CITY OF ALBUQUERQUE

December 29, 2004

**Re: Church's Chicken, 2307 Juan Tabo Blvd NE, Traffic Circulation Layout
Architect's Stamp dated 12-21-04 (H21-D48)**

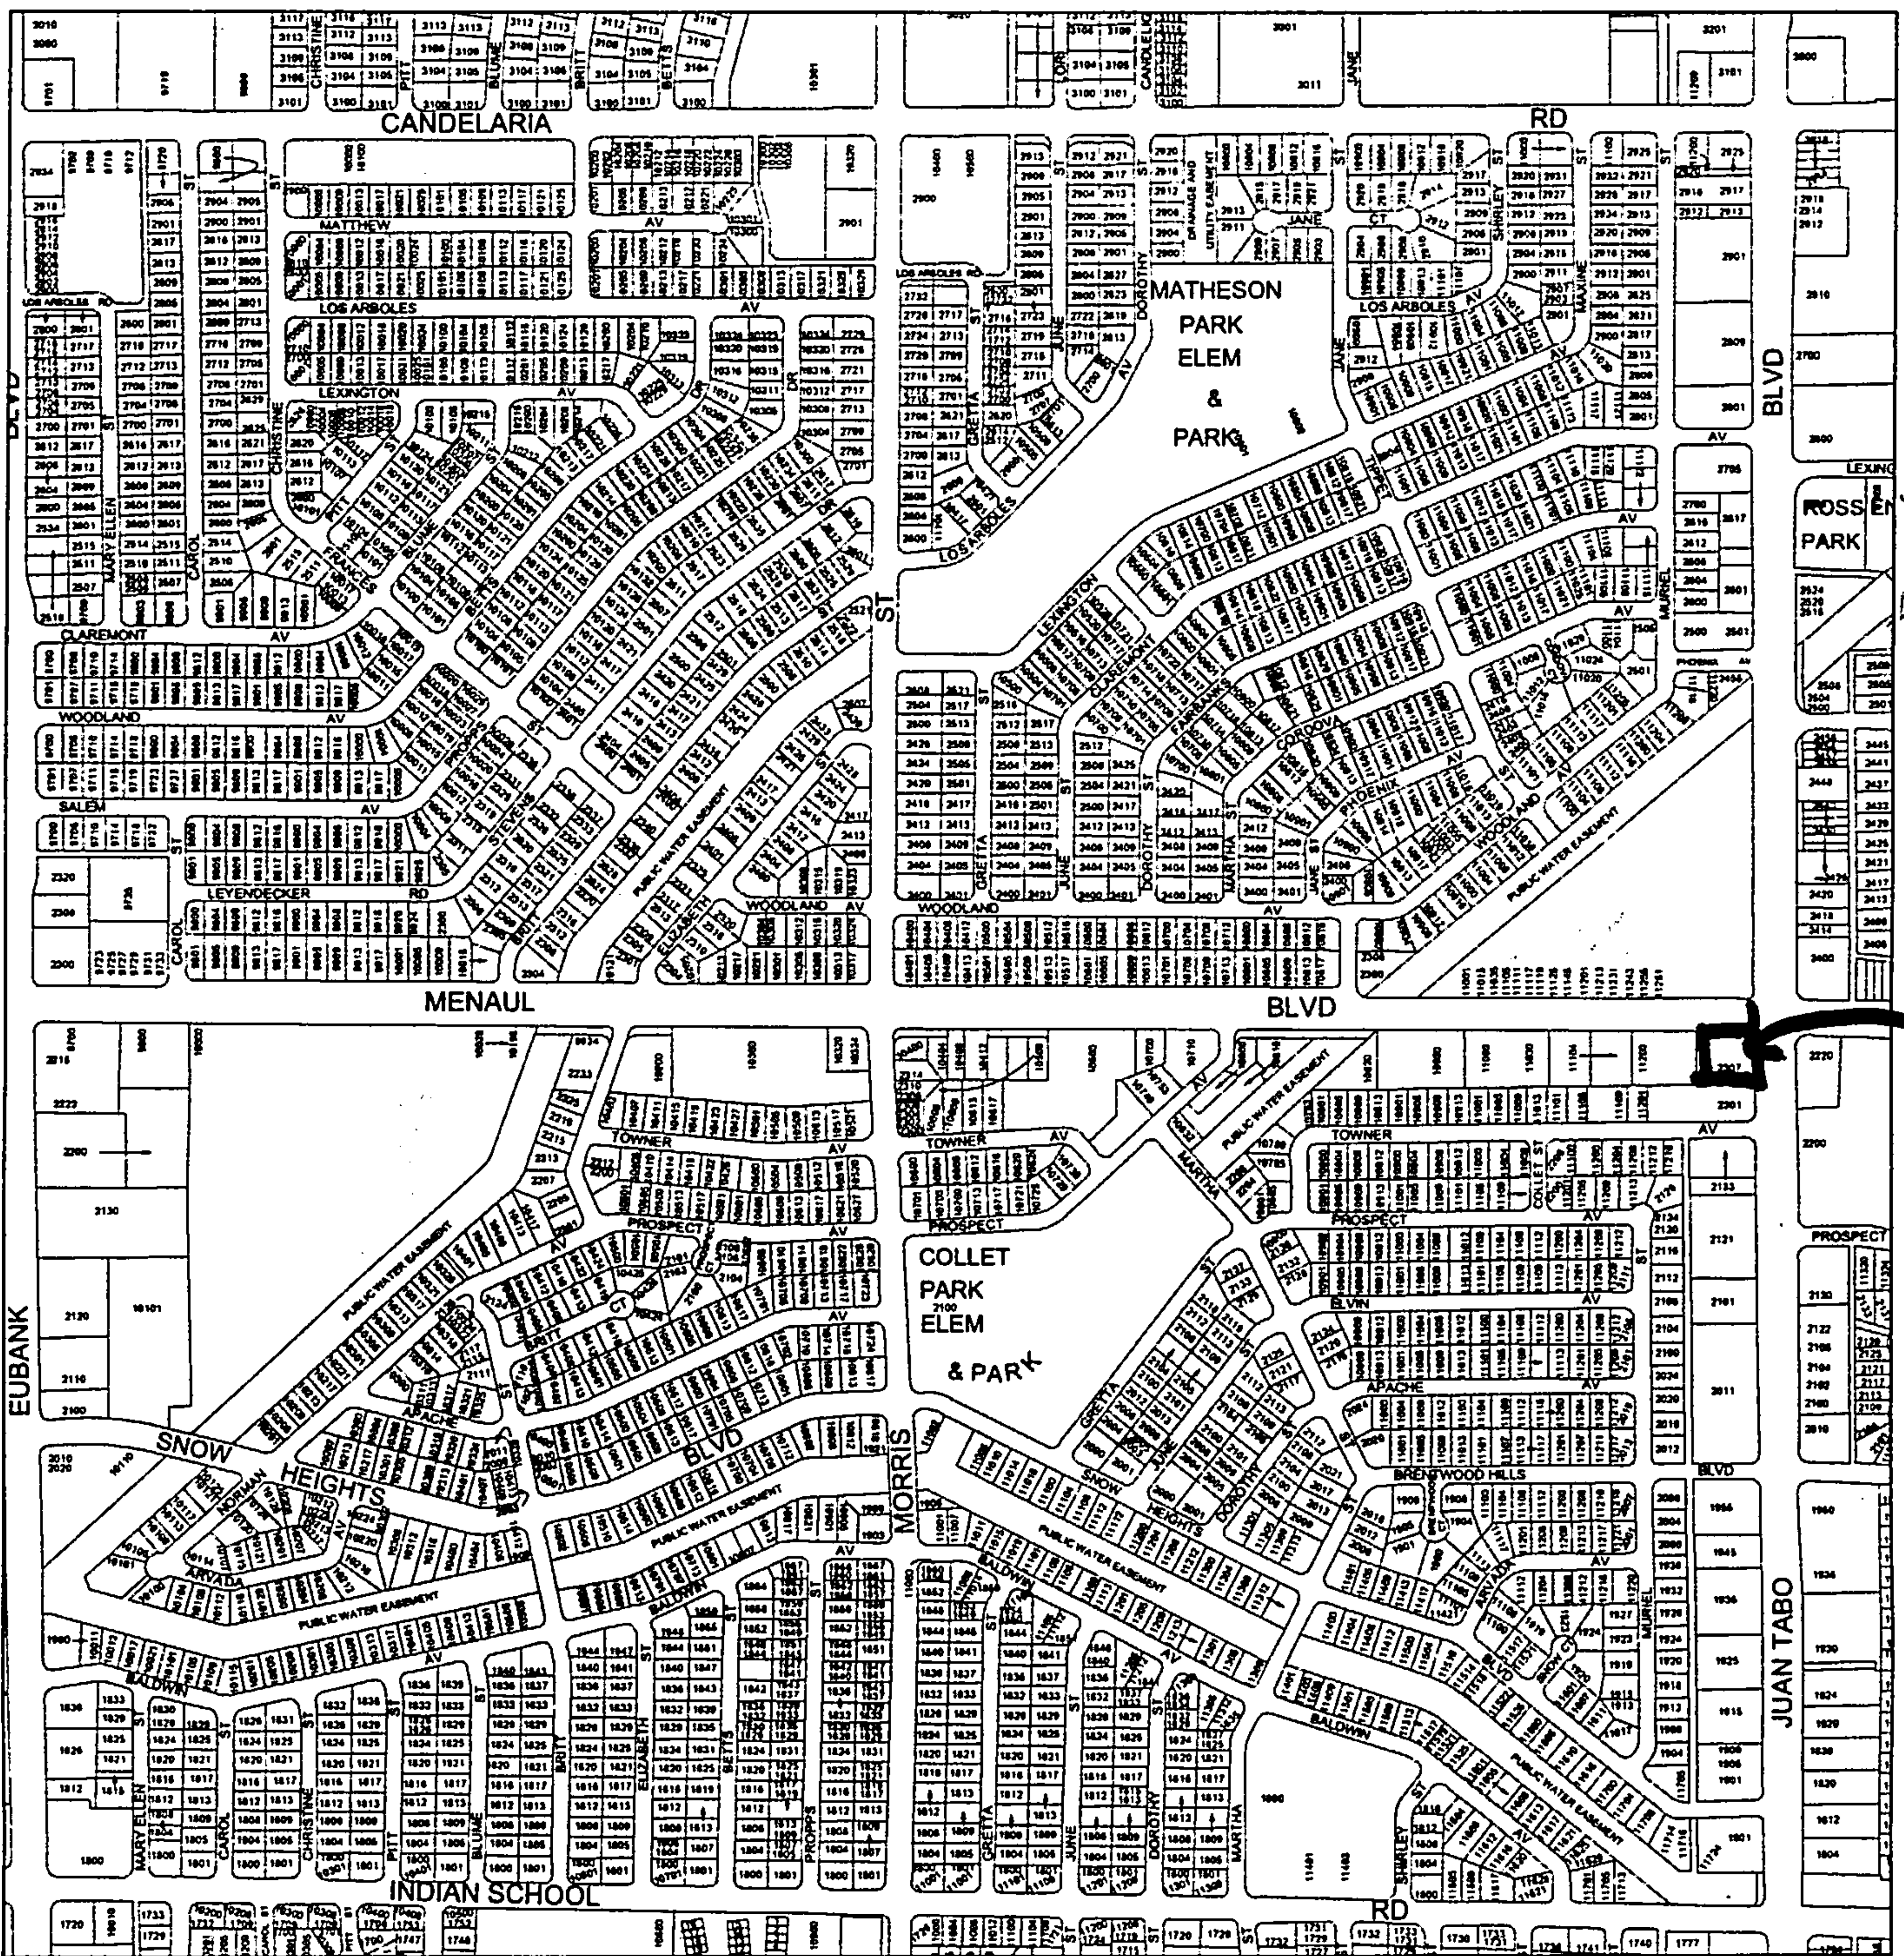
Via Map on plan

Scale of plan?

Indicate exists vs proposed structures, etc

15' min radius

show how vehicle ~~can~~ get through drive thru

spaces required

6' ~~min~~ sidewalk req.

Refer to City Std

* Close rather drive on Juan T. foo - too close to intersection
